## RE: Oakdale West Estate Stage 3 Development (SSD-9794683) – Response to TfNSW RFI

**Table 1: TfNSW Comments (18/03/2021) and Ason Group Response**

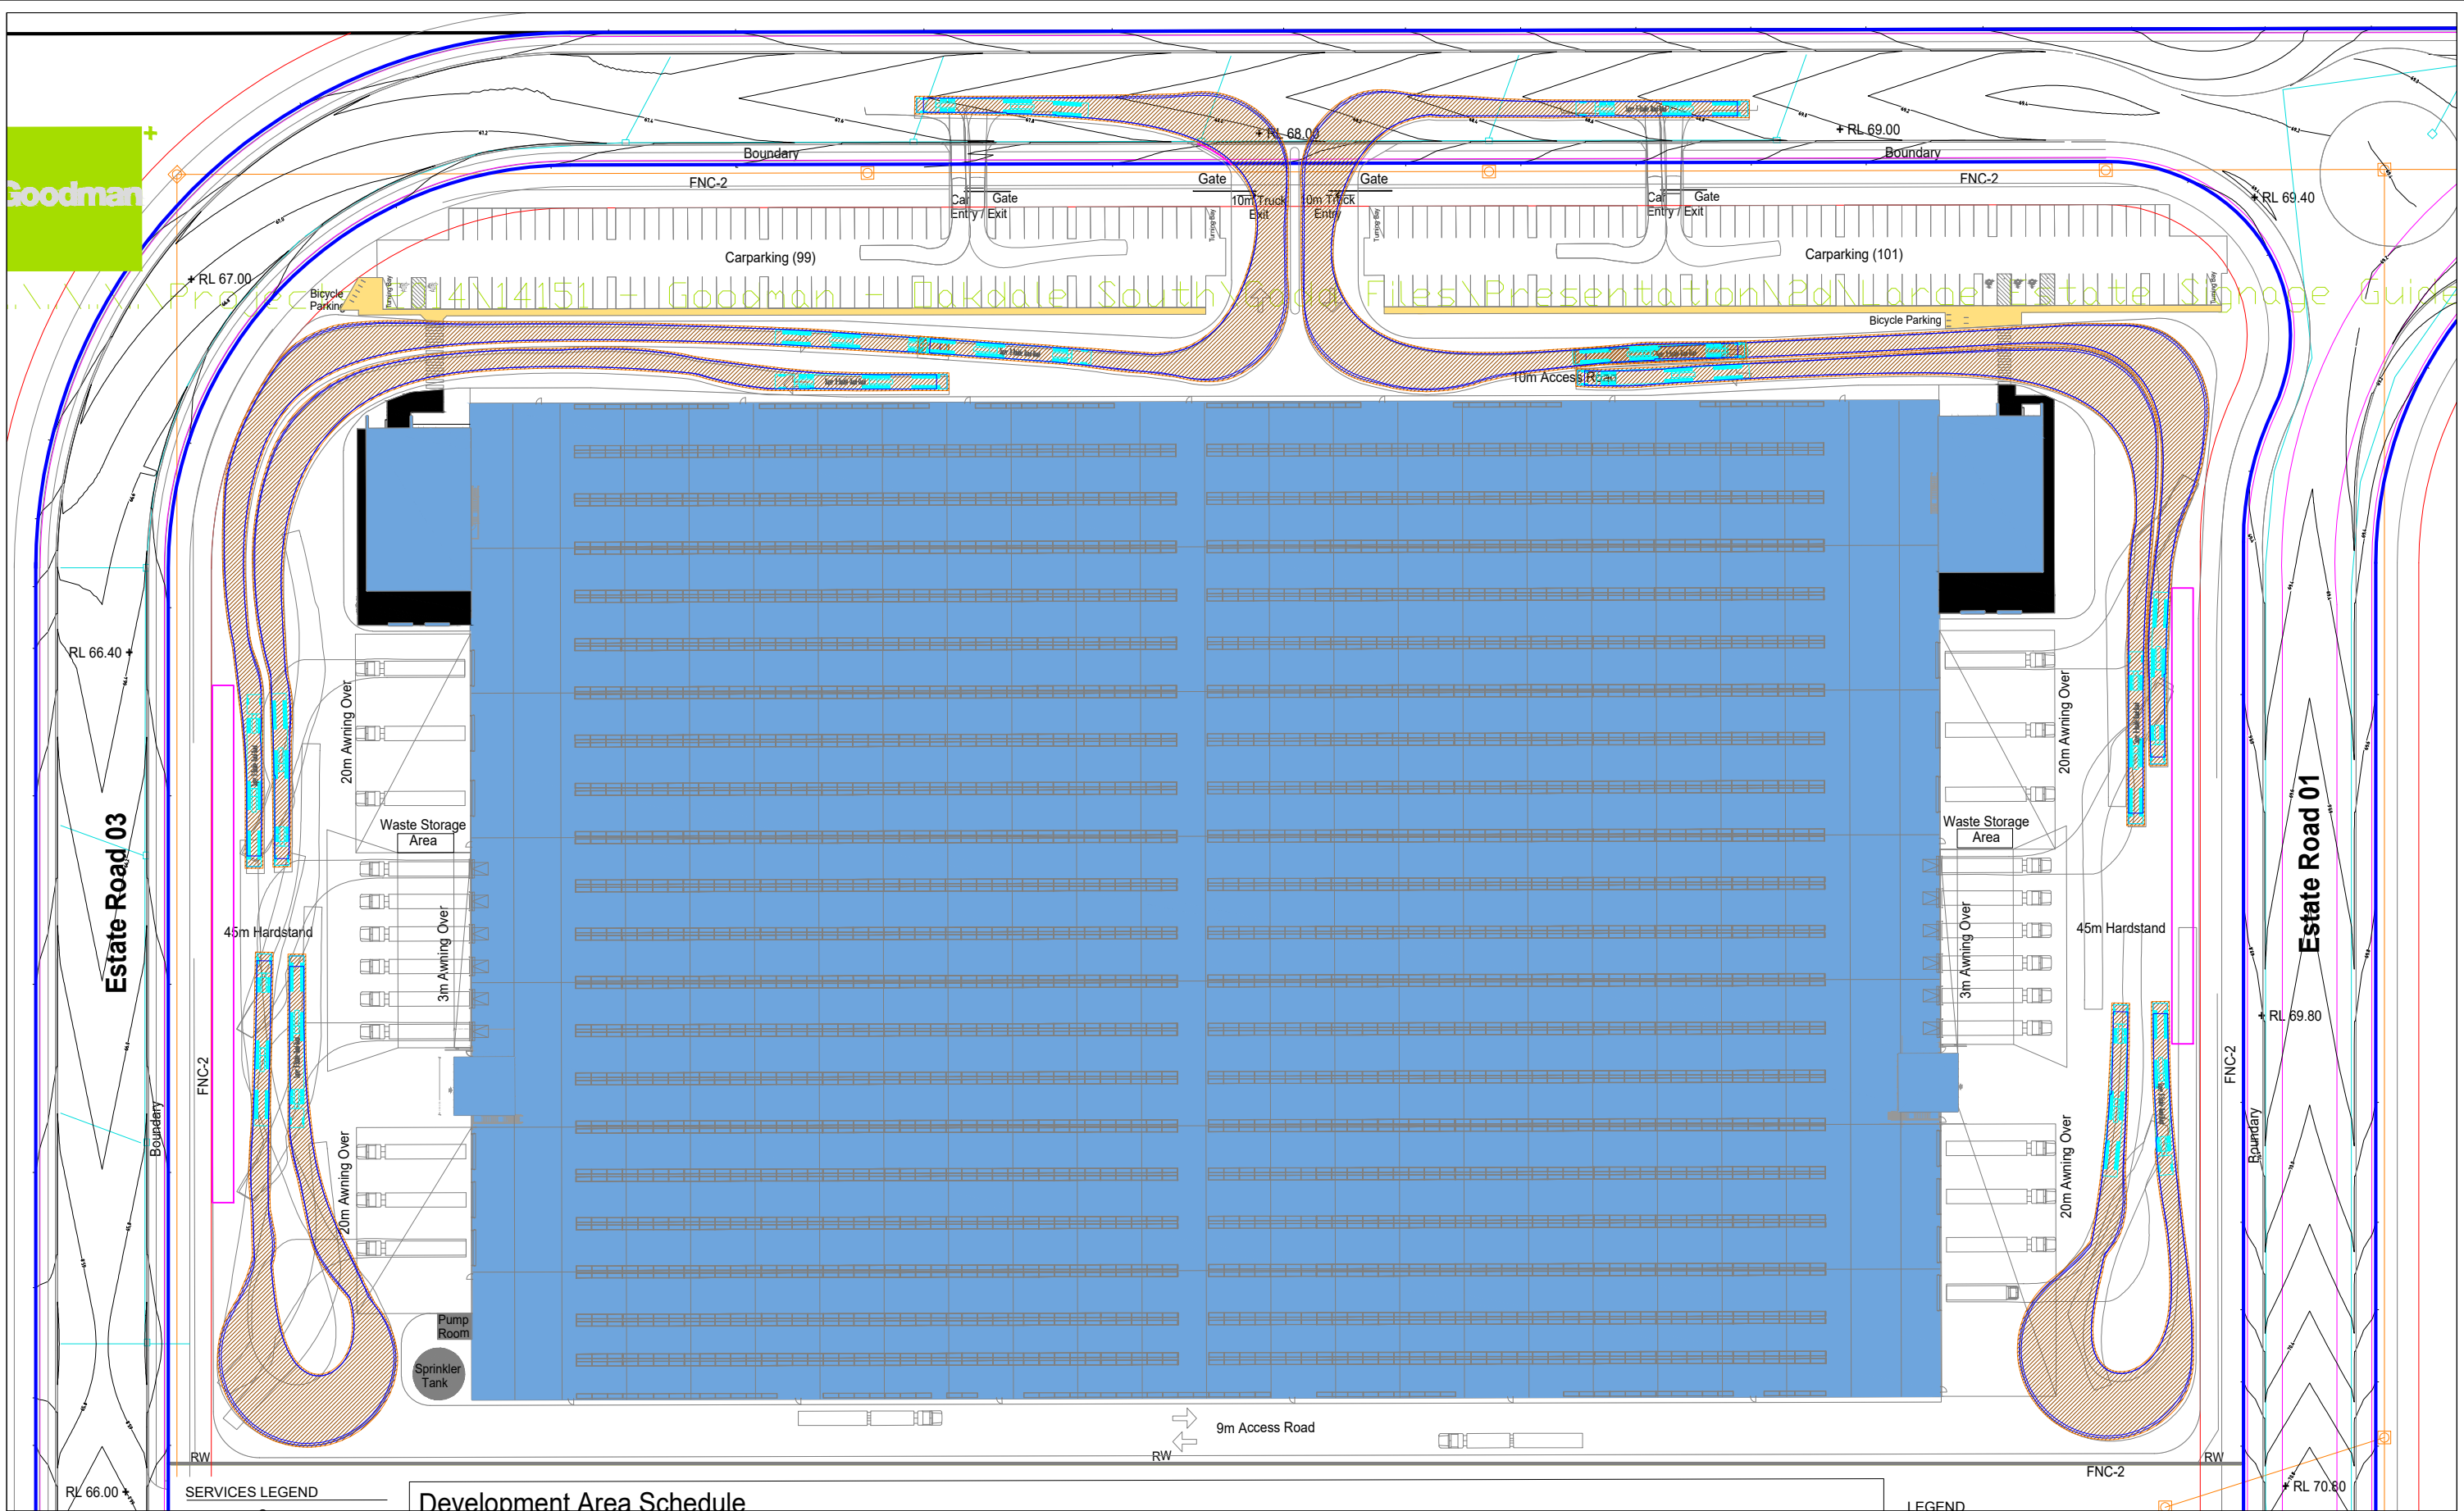
Item No.	TfNSW Comment	Ason Group Response
11	<p><b><u>Comment:</u></b></p> <p>The swept path plans for Building 2A indicate that simultaneous entry/exit cannot be achieved with the largest vehicles. This can lead to conflict points at the access to the lots where 2 opposing vehicles are attempting to use these accesses at the same time.</p> <p><b><u>Recommendation:</u></b></p> <p>The design of the access points should allow for simultaneous entry/exit movements of the largest vehicle. The swept path of the longest vehicle entering and exiting the subject site, shall be in accordance with AUSTRROADS and to the satisfaction of Council.</p>	<p>Site access for Building 2A has been widened to allow for simultaneous entry/exit movements of super B-doubles. It now provides separate entry and exit points with 2 metres median for pedestrian refuge.</p> <p>Relevant swept path analysis is included in Attachment 2.</p> <p>It is noted that, in order to provide this separate entry and exit at Building 2A, the revised scheme has resulted in a total reduction of 8 car parking spaces, which indicates a deficit of 7 car parking spaces.</p> <p>In general, staff arrival / departure time of warehouses are scheduled staggered; therefore, it is expected that the proposed car parking provision can still sufficiently accommodate on-site parking demand.</p> <p>Furthermore, additional car parking spaces can be provided as provisional spaces within hardstand area based on actual on-site parking demand of future tenant, if required.</p>

12	<p><b><u>Comment:</u></b></p> <p>In addition to the above point, it is noted that the design of the internal road network within Building 2A does not allow for continuous 2-way flow.</p> <p><b><u>Recommendation:</u></b></p> <p>The design should be updated to allow for the continual 2-way flow along the main access road, in particular on the corners where there is restricted sight distance to the satisfaction of Council.</p>	<p>Site Plan for Building 2A has been updated to allow for continuous 2-way flow of super B-doubles.</p> <p>Relevant swept path analysis is included in Attachment 2.</p>

**Drawing Title:**  
 Swept Path & Unhooking Location  
 30.0m Super B-Double

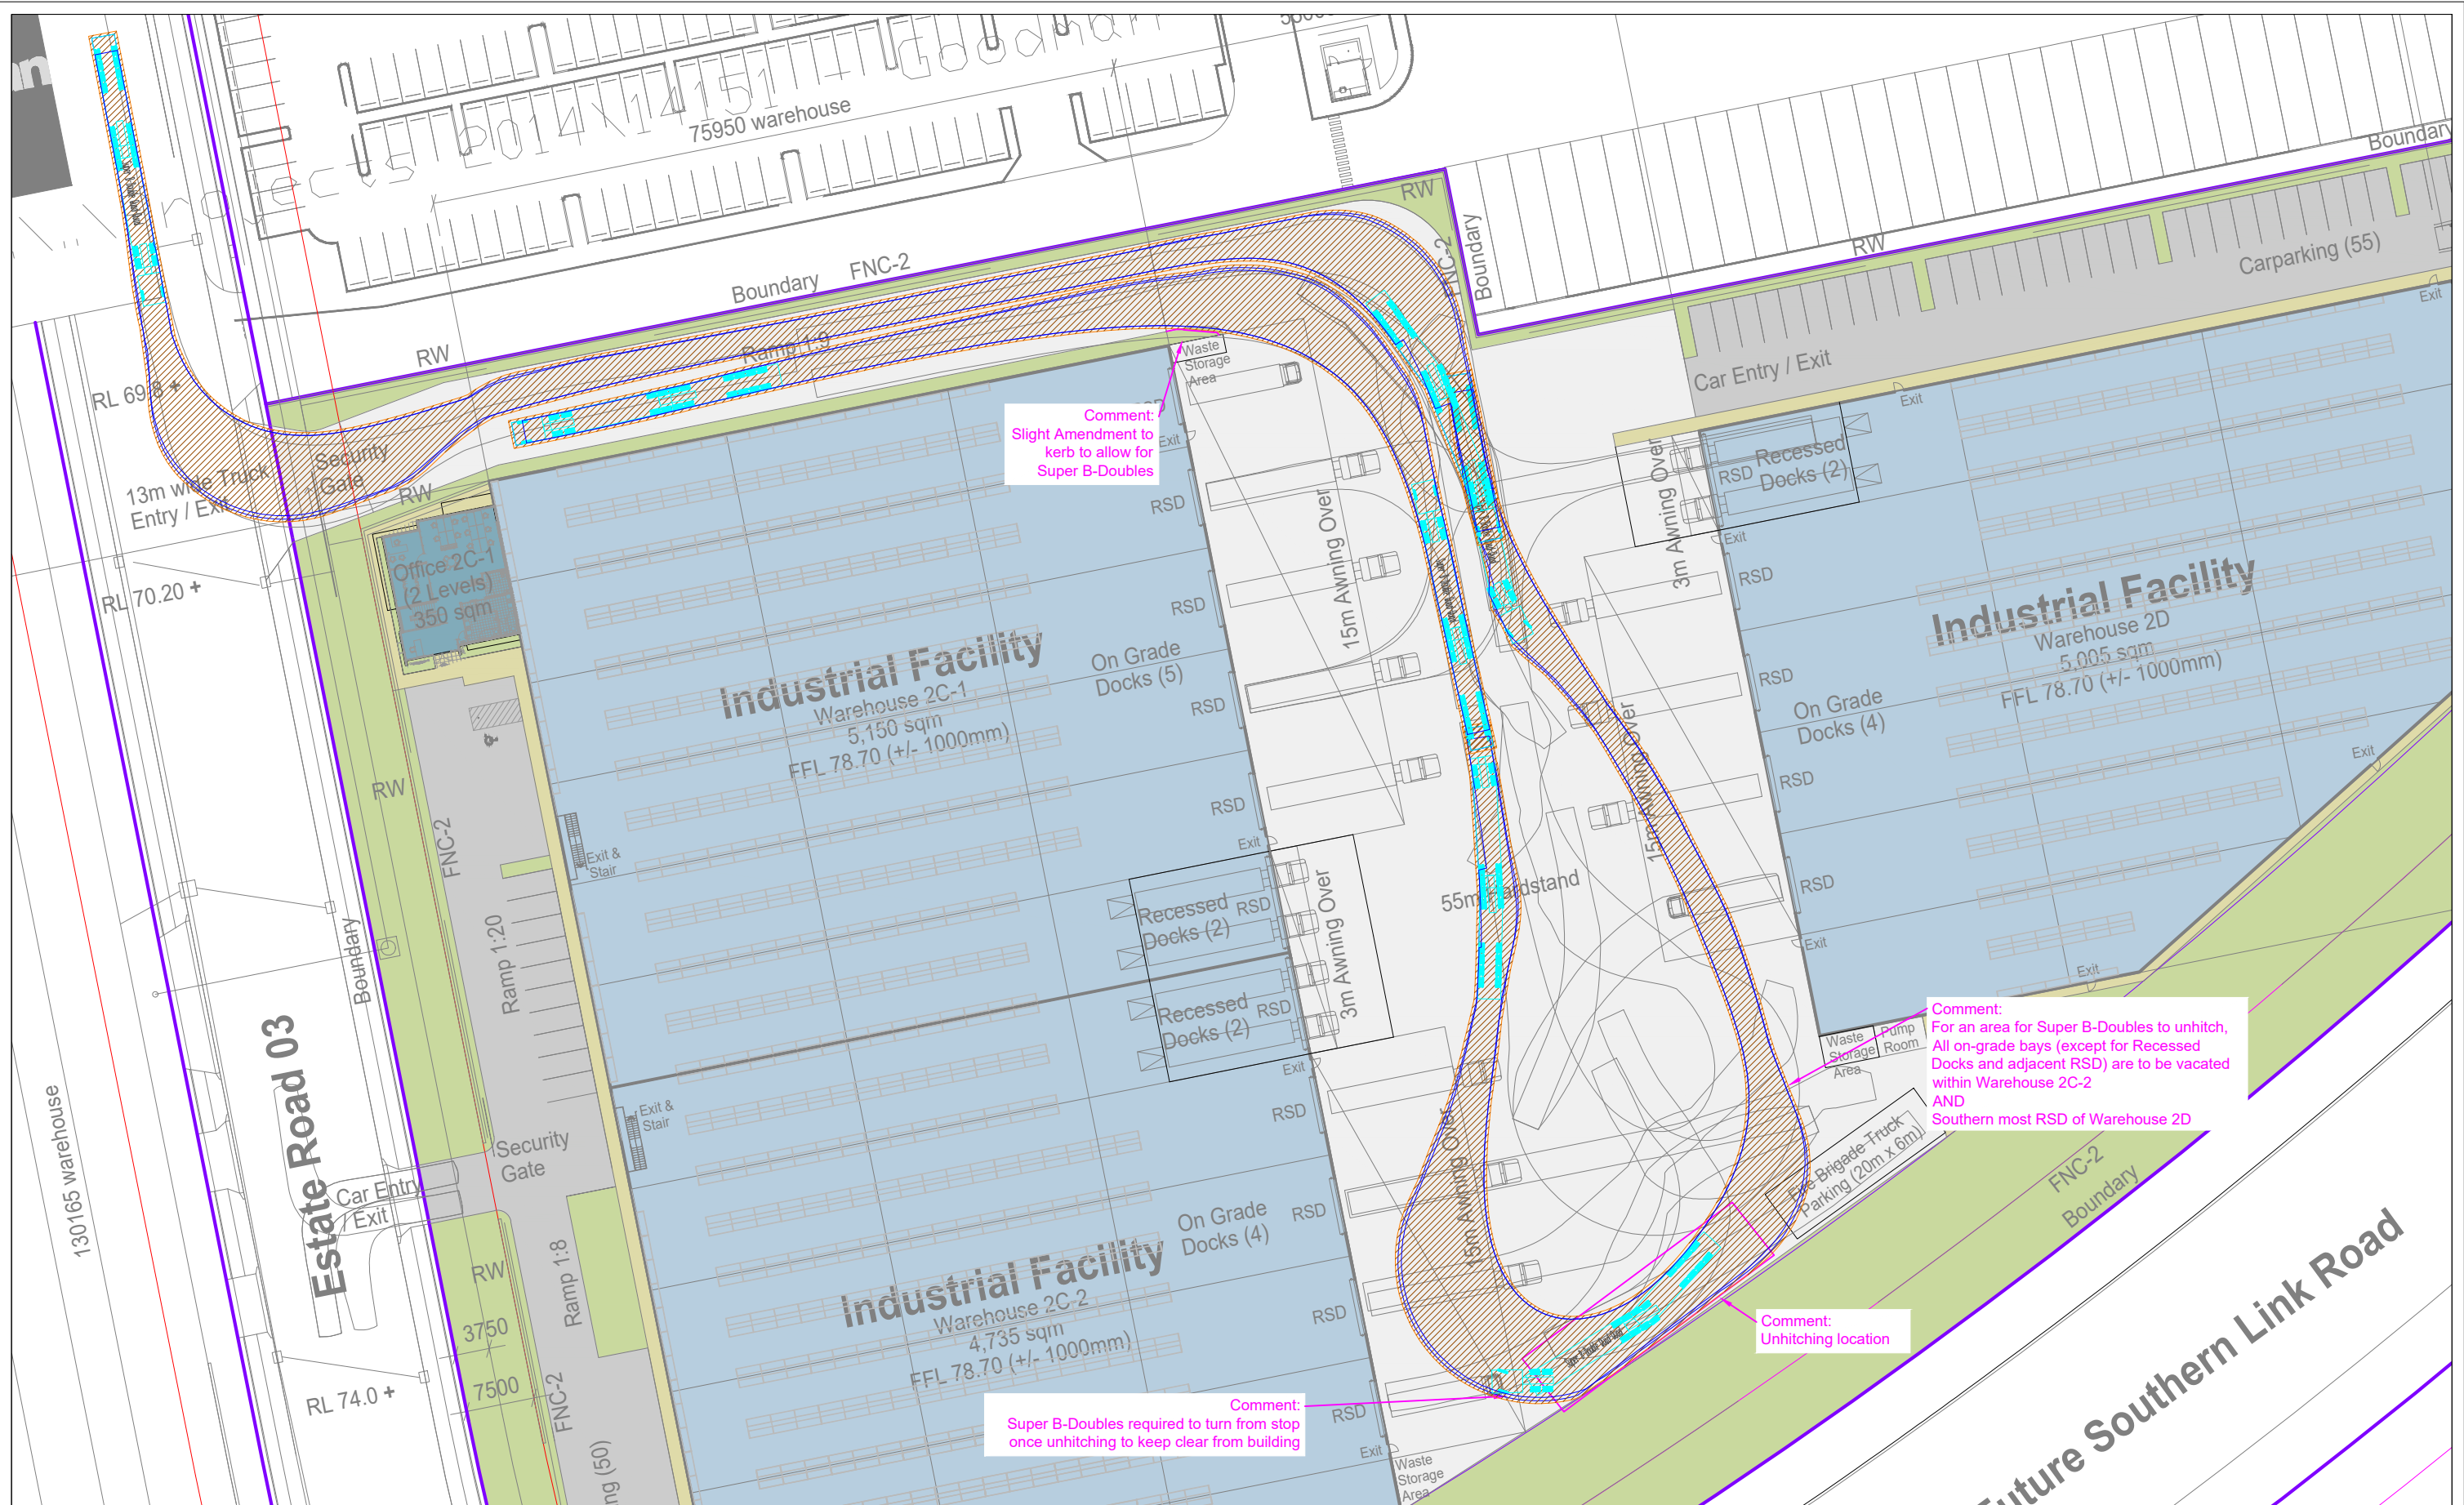
Item No.	TfNSW Comment	Ason Group Response
5	<p><b><u>Comment:</u></b></p> <p>There are no details on driver facility or staging area that will be provided in OWE.</p> <p><b><u>Recommendation:</u></b></p> <p>It is requested the proponent provide details of any driver facilities or staging areas that will be provided in OWE.</p>	<p>Based on the advice provided by AT&amp;L, it is noted that there are no staging areas within the estate. All staging is to be undertaken on the development lots.</p> <p>In this regard, for Building 2A we have proposed an unhitching area (refer to Attachment 2) with swept paths analysis undertaken for super B-doubles.</p> <p>It is noted that for Building 2C and 2D, the unhitching area has been nominated; however, attendance of larger trucks such as B-doubles / super B-doubles as necessary shall be subject to operational management plan to facilitate these movements.</p> <p>It is expected that the operational management plan will be prepared as part of the OC stage of the project and can be included as a suitable CoC.</p>
